This Service Information bulletin supersedes S.I. B12 10 07 **dated July 2007.**

NEW Recall Campaign 07V-479: N62TU - Retrofit Engine Compartment Ground Cables

E60, E63, E64, E70 with N62TU produced 03/05-06/07

Cylinder bank 1-4.

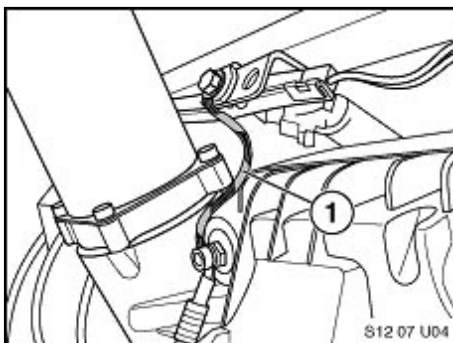
- Remove M5 bolt (1) from the injection rail and install ground cable (P/N 12 52 7 581 845) with the crimp facing upwards.
- Connect the other end of the ground cable to the grounding point of the ignition coils (2), located in front of the VVT motor. Crimp connector has to be pointing upwards.
- Torque both fasteners to 5 Nm.

Cylinder bank 5-8.

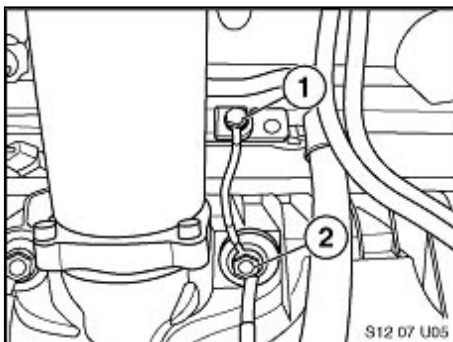
- Position the ground cable (1) as shown on the illustration.

- Remove M5 bolt (1) from the injection rail and install ground cable (P/N 12 52 7 581 845) with the crimp facing upwards.
- Connect the other end of the ground cable to the grounding point of the ignition coils (2), located behind the VVT motor. Crimp connector has to be pointing upwards.
- Torque both fasteners to 5 Nm.
